Swan and Canning Rivers Management Act 2006

DETERMINATION OF DEVELOPMENT APPLICATION

FILE NUMBER	:	2023-5095
APPLICANT	:	Rowe Group
LANDOWNER	:	City of South Perth
LAND DESCRIPTION	:	Portion of Lot 11835 on Plan 240379 (Reserve 34565) and Lots 778 on Plan 163503 and 780 on Plan 91394 Coode Street, South Perth
DEVELOPMENT	:	Redevelopment of Wesley boatshed including: the demolition of the existing boatshed and the construction of a boatshed for Wesley and Penrhos colleges
VALID FORM 1 RECEIVED	:	27 September 2023
DETERMINATION	:	APPROVAL WITH CONDITIONS

PROPOSAL	Redevelopment of Existing Boatshed for Wesley College and Penrhos College
LOCATION	Portion of Lot 11835 on Plan 240379 (Reserve 34565) and Lots 778 on Plan 163503 and 780 on Plan 91394 Coode Street, South Perth
COST	\$2,400,000
APPLICANT	Rowe Group on behalf of Wesley College and Penrhos College
LANDOWNER	Land under the care, control and management of the City of South Perth
LOCAL GOVERNMENT	City of South Perth
MRS CLASSIFICATION	Parks and Recreation Reserve
DECISION TYPE	Part 5, <i>Swan and Canning Rivers Management Act 2006</i> , Ministerial Determination
ATTACHMENTS	<p>1A Amended Development Proposal 1B Initial Develop

Figure 3: Floor plan showing internal layout of proposed boatshed (9 February 2024)

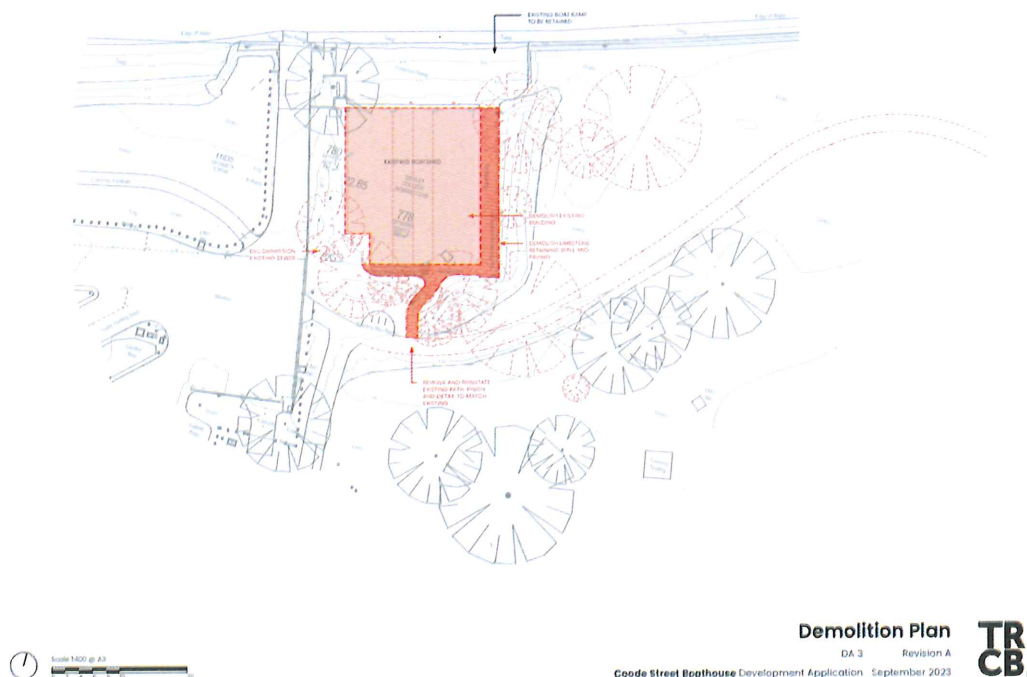
- 6.6 The proposed development (refer **Figure 3**) includes the construction of:
- a boatshed, consisting of five (5) roller door boat storage bays, 66m² rowing gym, kitchen, storage, toilet and changeroom facilities

- new landscaping, pedestrian pathways and the planting of 24 mature endemic trees.
- 6.7 The proposed boatshed increases the floor area of the building to 982m² (roof cover 1,103m²) and has a length of 42.97m.

- 6.8 The proposed boatshed will have a wall height of 5.51m and an overall height of 8.58m. The existing boatshed has an overall height of 5m. This represents an increase in the total height of the building of 3.58m.

Figure 4: Amended site plan detailing foreshore setbacks (28 March 2024)

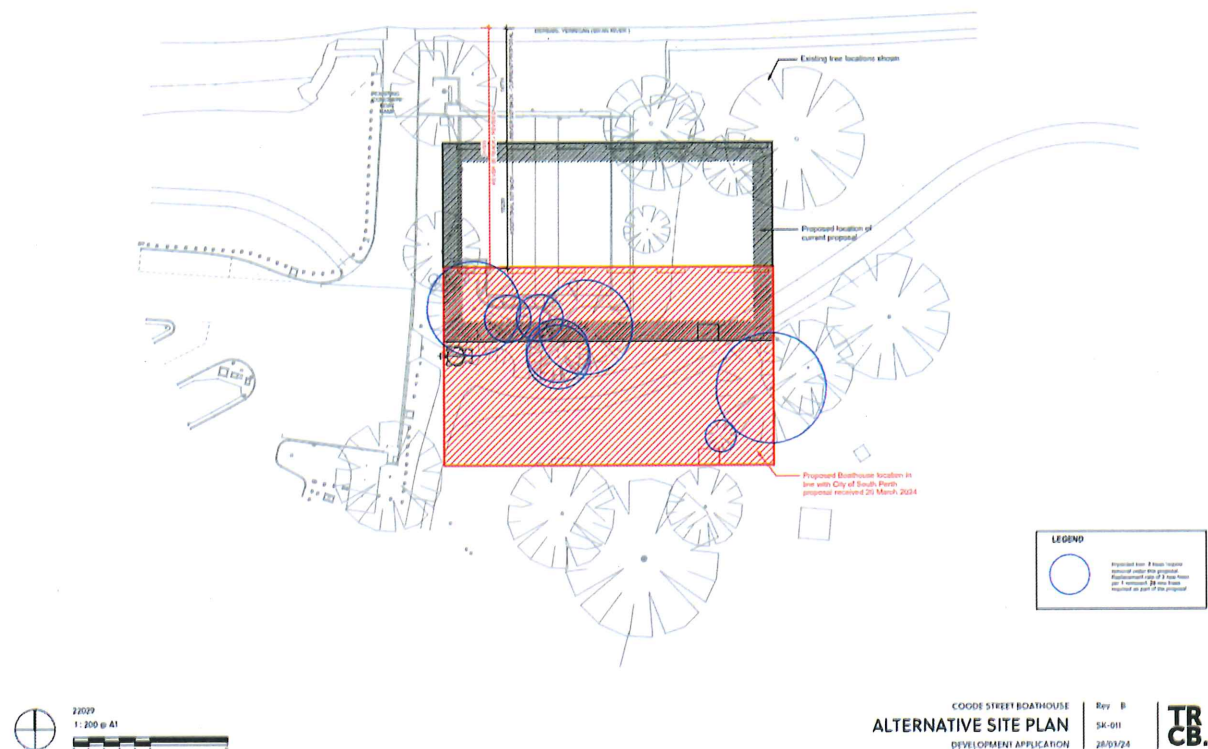
6.9 As part of later negotiations between DBCA, the colleges and the City regarding the consideration of amended plans, the setback of the proposed boatshed has been increased from 12.75m to 31m (refer **Figure 4**). The amended design includes relocation of the pedestrian access along the foreshore between the river and the proposed boatshed as well as planting around the site to soften the visual impact of the boatshed.

- 7.32 Discussions between DBCA, the colleges and the City in March 2024 resulted in the submission of a concept plan on 28 March 2024 that propose an increased setback of 31m to the proposed boatshed.

- 7.47 The Applicant submitted an amended concept plan on 28 March 2024 that illustrated an increased setback of 31m to the proposed boatshed.
- 7.48 The increased setback will enable the future foreshore enhancement works to respond to the principles and objectives of Perth Water Buneenboro Locality Plan, SPP 2.10 and Policy 42. The City's aspirations to provide a softer foreshore interface that facilitates community access to the river along with providing greater environmental benefits can also be achieved with this design modification.

Figure 5: South elevation detailing proposed building materials (view from playground/family picnic area)

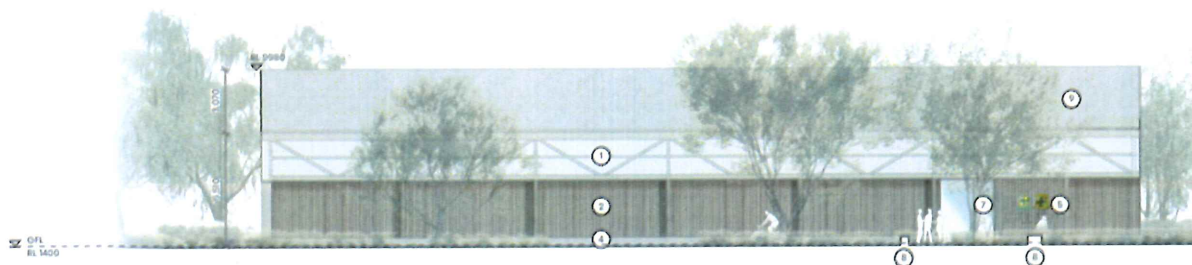
6.10 The boatshed is proposed to be constructed of hardwood cladding and metal roller doors for the walls, corrugated polycarbonate sheeting and colorbond metal roofing (shale grey) for the roof structure (refer **Figure 5**).
